Architectural Review Board Meeting Agenda

Thursday, January 16, 2025 at 5:30 p.m.

1. Project: Rolph Residence Addition and Remodel, Project 22-2182-ARB/CDP
Address: 4715 Aragon Drive
Applicant: Alex Pujo, architect, for Mark Rolph
Planner: Syndi Souter

2. Project: Dish Wireless Telecommunications Facility, 24-2292-CUP/CDP/ARB
Address: 6267 Carpinteria Avenue
Applicant: Harold Thomas Jr, MD7 Architecture, for Dish Wireless, LLC
Planner: Brian Banks

EAST & WEST

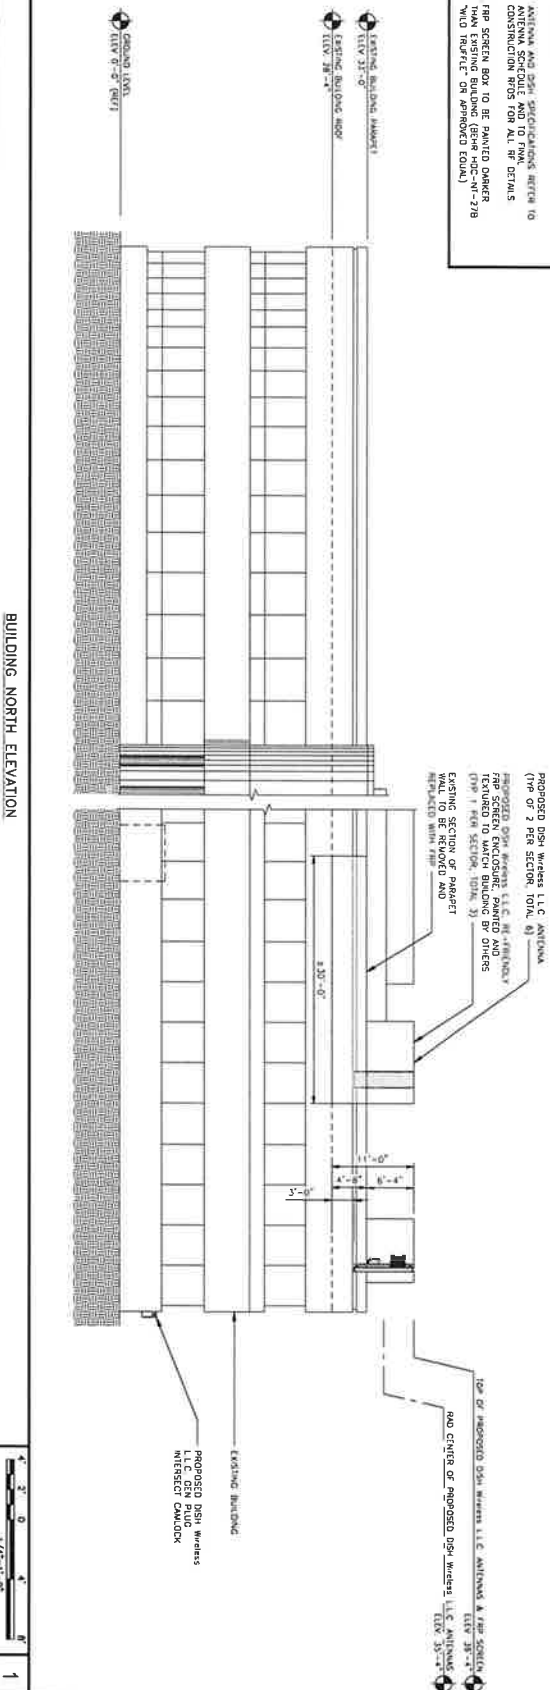
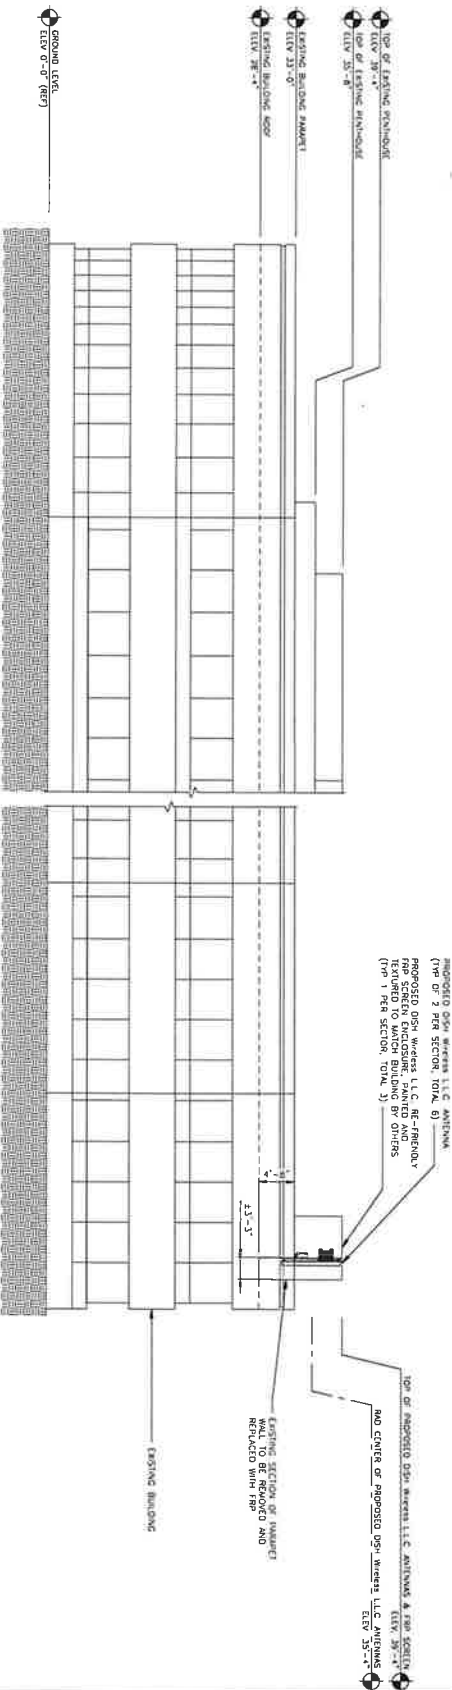
Boardmember Johnson commented that these types of facilities are common around the City and are innocuous. He recommended that the applicant study pulling the antenna and enclosures back at least a few feet from the building edge to break the plane of the continuous fascia line of the building. Boardmember Johnson also suggested painting the screening element a slightly darker color than the body of the building to help minimize its appearance and suggested that adding more detailing would unnecessarily draw attention to the screening element.

ACTION: Motion by Vice Chair Blakemore, seconded by Boardmember Johnson to recommend preliminary approval to the Planning Commission with the condition that the applicant study the potential to push the projections back from the building face without increasing their height, and study using a darker paint color.

In response to the ARB's preliminary review comments, the project plans have been revised to incorporate both a substantial setback from the façade of the building (over 4 feet), and the use of a darker brown-gray color for the antenna screening elements ("Wild Truffle" BEHR HDC-NT-27B). Overall, staff is supportive of the project as proposed and believes the applicant has satisfactorily responded to the ARB's previous comments.
